Bill No. 03R-301

TITLE: USE PERMIT NO. 149, requested by Kent Seacrest on behalf of Ridge Development Company and Southview, Inc., for approximately 166,100 sq. ft. of commercial floor area, with associated waiver requests, on property generally located at the northwest corner of the intersection of S. 27th Street and Yankee Hill Road.

LINCOLN CITY/LANCASTER COUNTY PLANNING STAFF REPORT

Use Permit #149

DRAINAGE AND DRAINAGE PLAN
STONE RIDGE ESTATES COMMERCIAL CENTER
USE PERMIT #149
LINCOLN, NEBRASKA

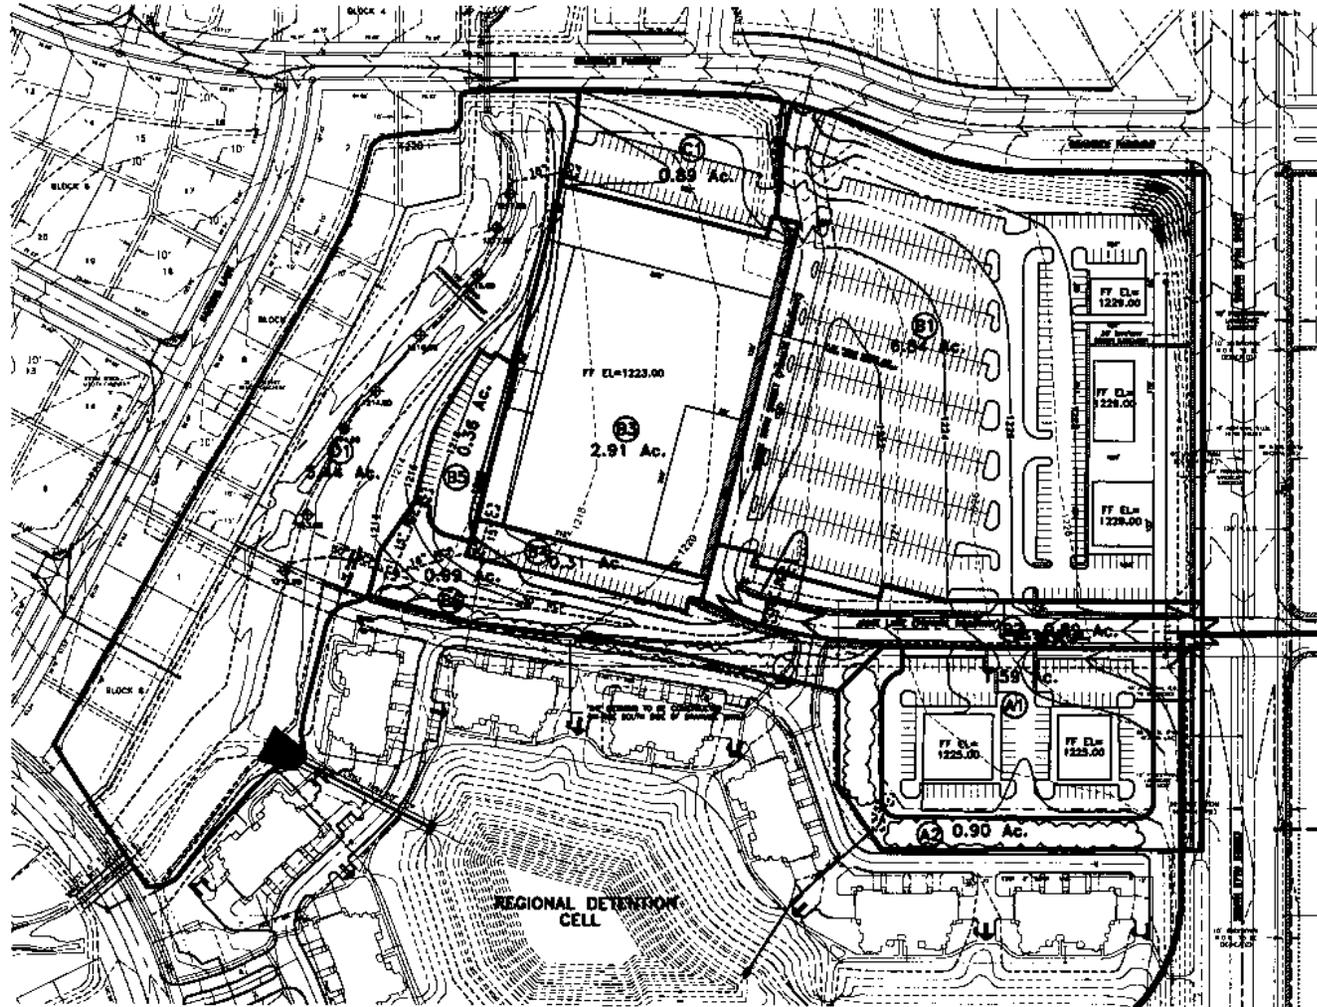
Sanitary Sewer - If Lots 2 and 3 develop as restaurants, they will most likely require separate sewer services with grease traps. As proposed there is no sanitary sewer in the vicinity of Lot 3.

Grading/Drainage - Show 100yr flood elevations in the existing channel to the west. Also, show finished floor elevations to ensure the structures are out of flood danger. Elevation labels should also be added to the existing and proposed contours.

A portion of the clouded area designated for berming in area B6 appears to be located in a drainage ditch. The contours and/or berm cloud should be adjusted accordingly.

The existing grades in the north east corner of the project indicate a portion of the parking located on a 3:1 slope. The grades should be adjusted accordingly.

Show the existing storm sewer along the west side of South 27th Street.

A waiver for detention ¹⁵~~needs to be~~ requested. This waiver ¹⁵~~would be~~ approved by Public Works as the master drainage plan for the area provides detention for this project down stream.

The building envelope for Lot 3 protrudes into the public access easement. Revisions should be made to remove the envelope from the easement.

There are two curve #5 listed in the curve data information. Also, there is a curve labeled

4 on the plan and there does not appear to be a curve present. Clarification is required.

10. Revisions to the grading and drainage plan are required per the attached reviews from Public Works and Utilities. The utility plan must also be revised as there is no sanitary sewer service in the vicinity of Lot 3. Public Works also notes that a waiver to storm water detention has been requested, as on-site detention is not provided on the plan. This is a waiver that may be approved administratively and has been granted by the Director of Public Works.

- 1.1.6 Corrected curve data for the private roadway.
- 1.1.7 A revised grading and drainage plan approved by Public Works and Utilities.
- 1.1.8 Note #10 revised to state "MINOR ADJUSTMENTS IN THE FLOOR AREA OF EACH BUILDING MAY MADE AT THE TIME OF BUILDING PERMITS PROVIDED THE TOTAL FLOOR AREA OF THE CENTER DOES NOT EXCEED 151,000 SQUARE FEET. ANY INCREASE IN FLOOR AREA ABOVE 151,000 UP TO THE MAXIMUM ALLOWED FLOOR AREA OF 166,100 MUST BE APPROVED BY ADMINISTRATIVE AMENDMENT."

- 1.1.9 Lot 3 not protruding into the public access easement.
- 1.1.10 Sanitary sewer service to Lot 3.
- 1.1.11 Revise Note 14 to delete the existing language and insert the following: "AT LEAST 50% OF THE EXTERIOR FACADE AREA OF BUILDINGS UNDER 30,000 SQUARE FEET SHALL BE BRICK, STONE OR CULTURED STONE. THE EXTERIOR MATERIALS OF THE PRIMARY FACADES (ABUTTING A PUBLIC STREET OR PRIVATE ROADWAY) FOR BUILDINGS 30,000 SQUARE FEET AND LARGER SHALL CONSIST OF BRICK OR STONE MASONRY, SPLIT-FACE CONCRETE MASONRY, ARCHITECTURAL PRE-CAST, SYNTHETIC STUCCO OR A COMBINATION THEREOF." (**Per Planning Commission, at the request of the applicant and agreed upon by staff, 8/06/03**)
